Final Environmental Statement

related to the operation of
**South Texas Project,
Units 1 and 2**

Docket Nos. 50-498 and 50-499

**U.S. Nuclear Regulatory
Commission**

Figure 4.2 South Texas Project, Units 1 and 2, transmission routes
Source: ER-0L Figure 3.9-1, Amendment 1, 11/22/78.

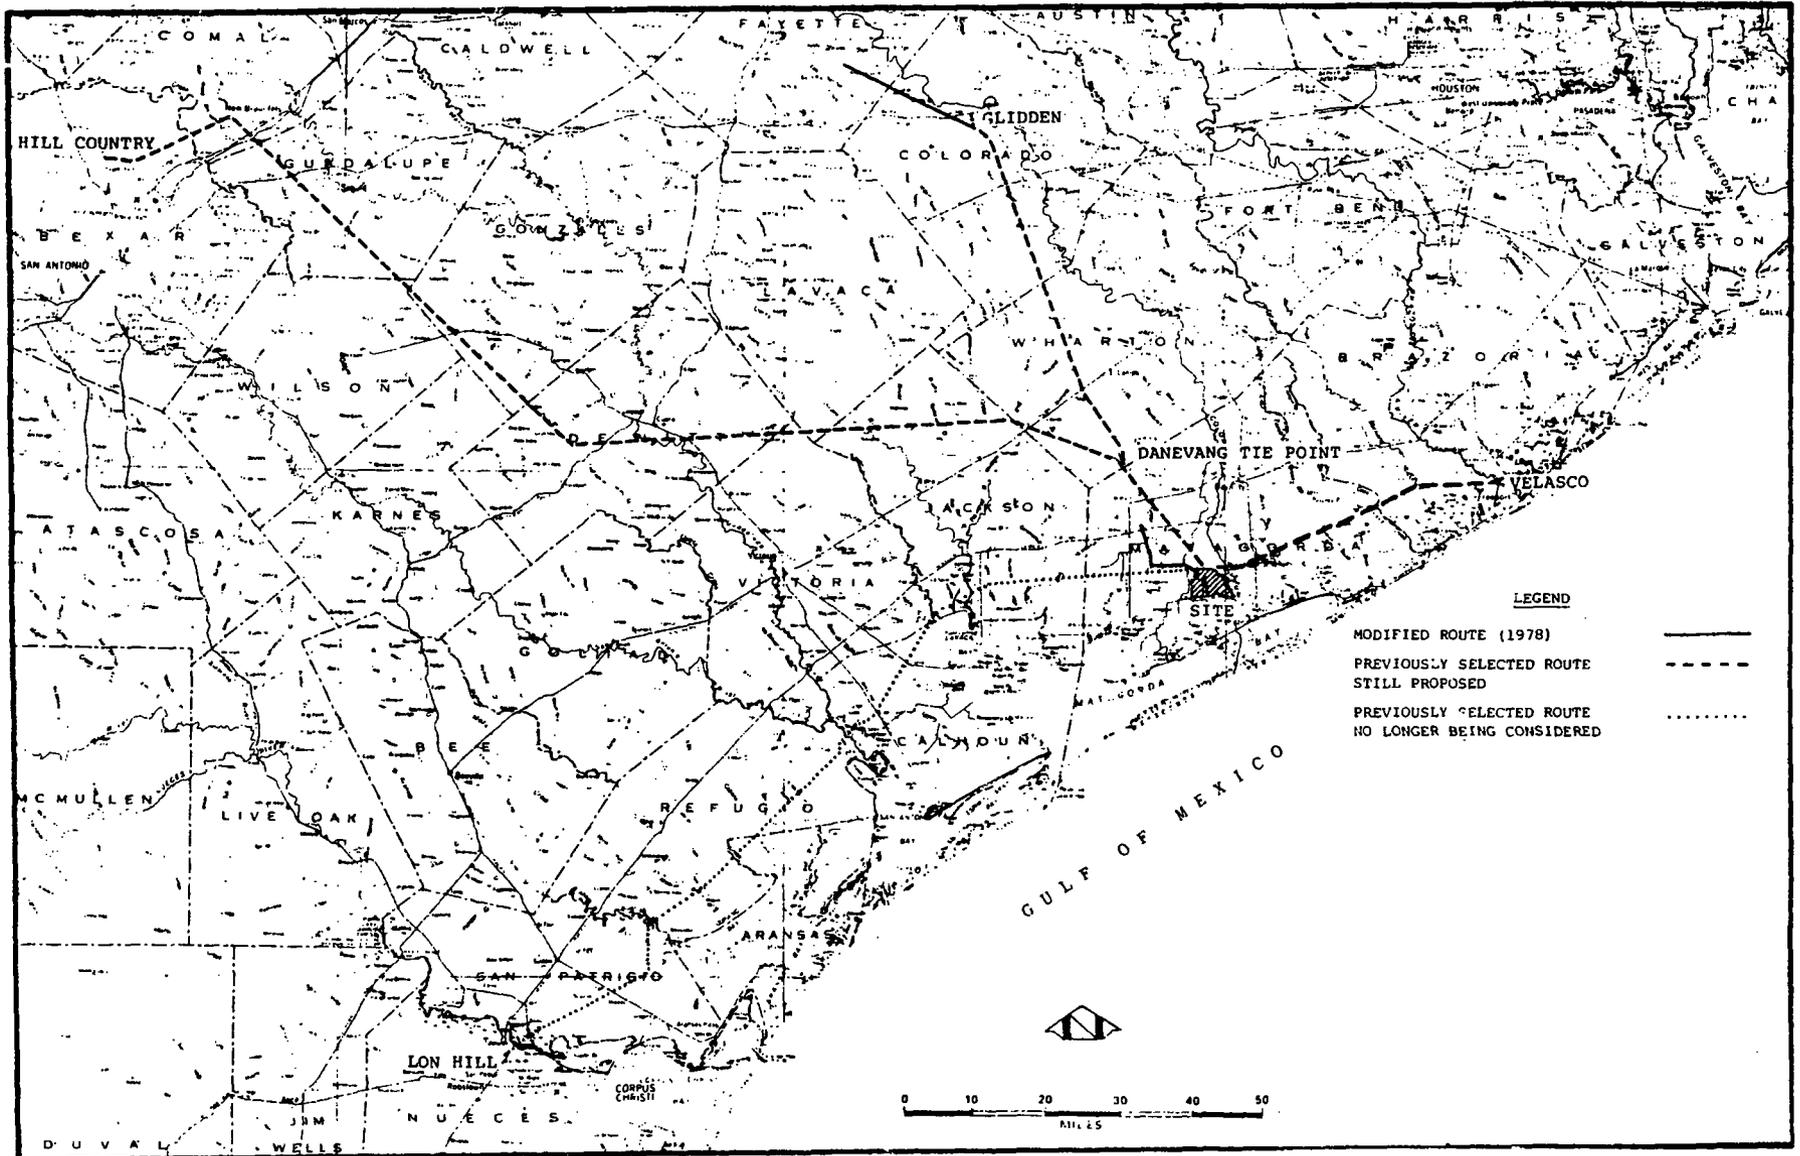
Section 4.2.7 on page 4-5 and accompanying Figure 4.2 on page 4-18 concerning Power Transmission Systems present an incomplete description of transmission lines associated with the project. Enclosed is a map of the area showing the existing 345 kv transmission lines emanating from the STP. When compared with Figure 4.2 some differences are indicated. First, as shown on the enclosed map, an existing line between Central Power and Light Company's (CP&L's) Lon Hill and Houston Lighting and Power Company's (HL&P's) W.A. Parrish generating plants jointly owned by the two Companies was looped through the STP. This is not shown on Figure 4.2. In addition the San Antonio City Public Service Board double circuit transmission line from STP has one circuit terminating at their Hill Country substation and the other at their Skyline substation which also is not shown on Figure 4.2. It should be noted that all major bulk transmission lines associated with the operation of the STP with the exception of CP&L's STP to Blessing line have been constructed and are in service.

1. Section 4.2.7 on page 4-5 and accompanying Figure 4.2 on page 4-18 concerning Power Transmission Systems present an incomplete description of transmission lines associated with the project. Enclosed is a map of the area showing the existing 345 kv transmission lines emanating from the STP. When compared with Figure 4.2 some differences are indicated. First, as shown on the enclosed map, an existing line between Central Power and Light Company's (CP&L's) Lon Hill and Houston Lighting and Power Company's (HL&P's) W. A. Parrish generating plants jointly owned by the two Companies was looped through the STP. This is not shown on Figure 4.2. In addition the San Antonio City Public Service Board double circuit transmission line from STP has one circuit terminating at their Hill country substation and the other at their Skyline substation which also is not shown on Figure 4.2. It should be noted that all major bulk transmission lines associated with the operation of the STP with the exception of CP&L's STP to Blessing line have been constructed and are in service.

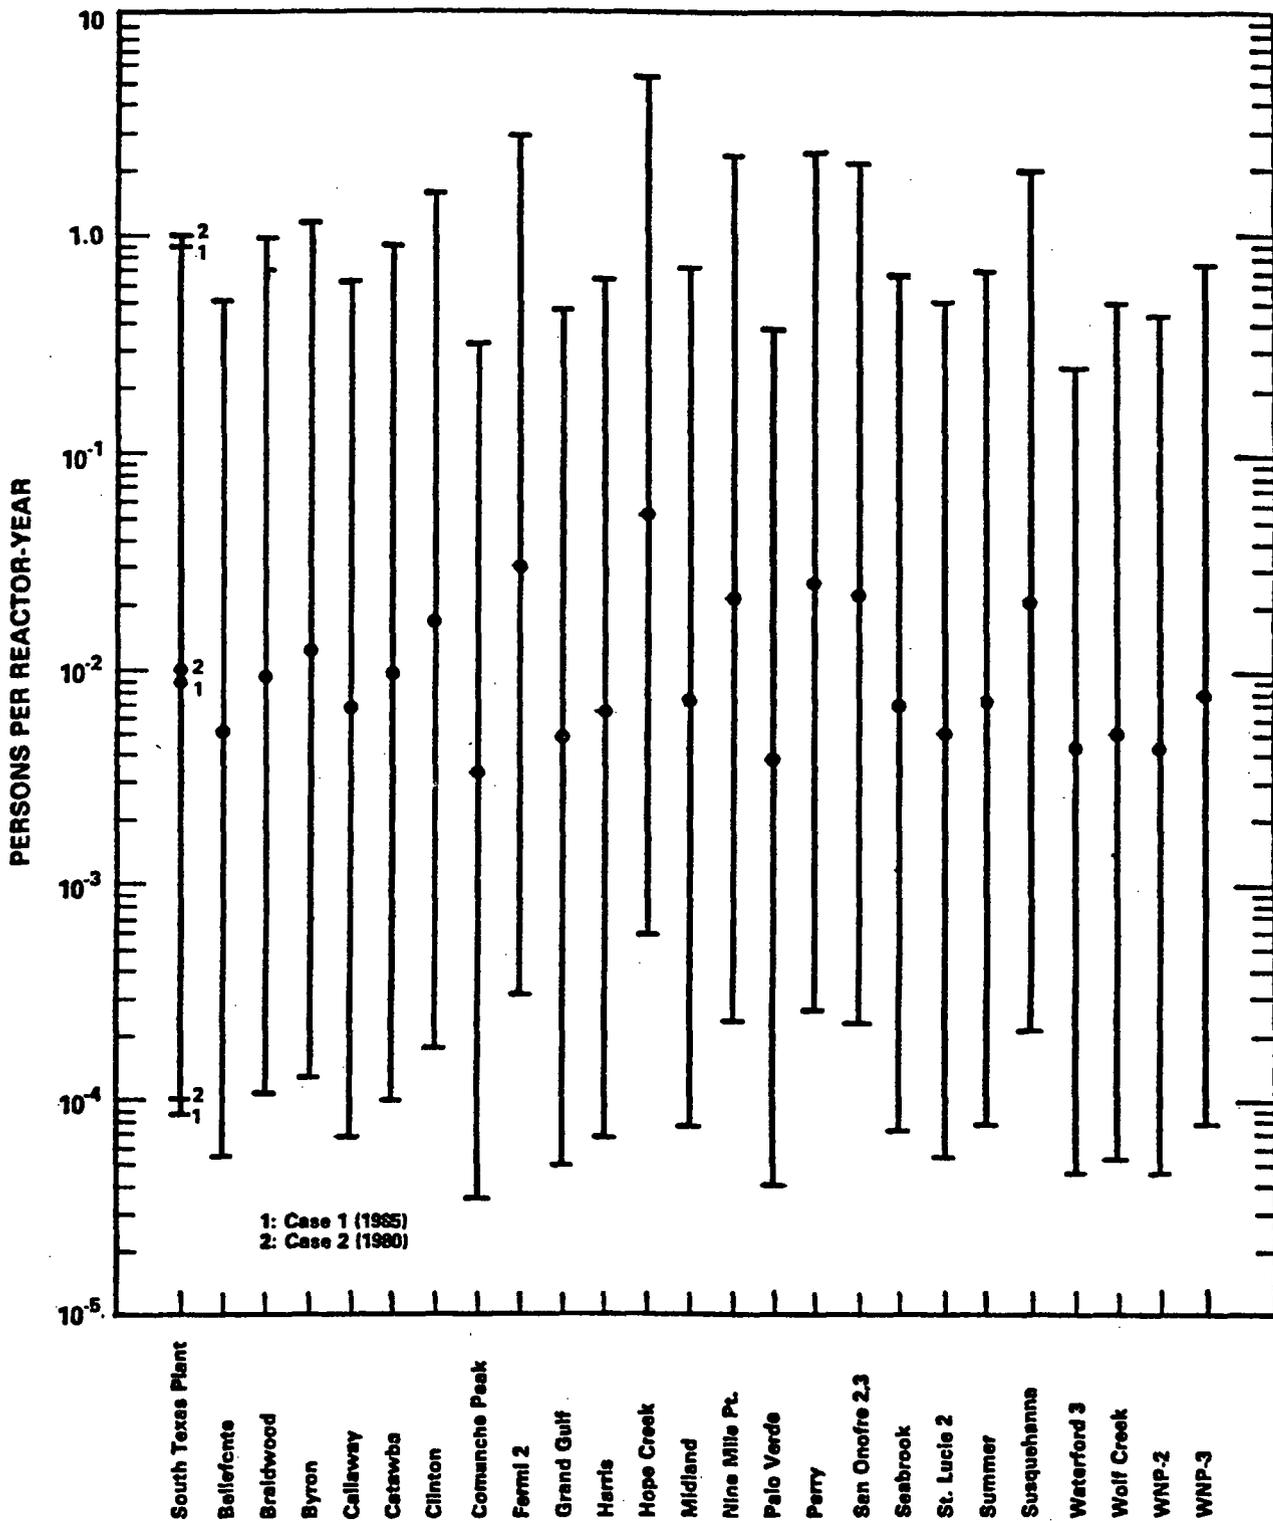
Regarding correction to the caption of either Figure F.15 or F.16

(3rd full paragraph, 1st sentence) Revise as follows: "Relief wells have been designed..." (See Attachment 2, page 27)
- Page 19 In the 1st paragraph the DES states that the applicant did not provide an estimate of effective porosity. HL&P provided an estimate in FSAR Amendment 51, page 2.4-61.
- Pages 38,39 Figures F.4 and F.5 should be switched with each other. The captions beneath each of the two figures appear to be in the proper location per the discussion in the 3rd and 4th paragraphs on page 15 of Appendix F. The figures and labels, however, are not in the correct location.
- Pages 44,45 Figures F.9 and F.10 appear to be switched according to the captions and the discussion regarding the figures on page 21 (last paragraph).
- Pages 50,51 Figures F.15 and F.16 have the exact same captions. One needs revision.

NRC Response: The appropriate change has been made to the caption on Figure F.16.
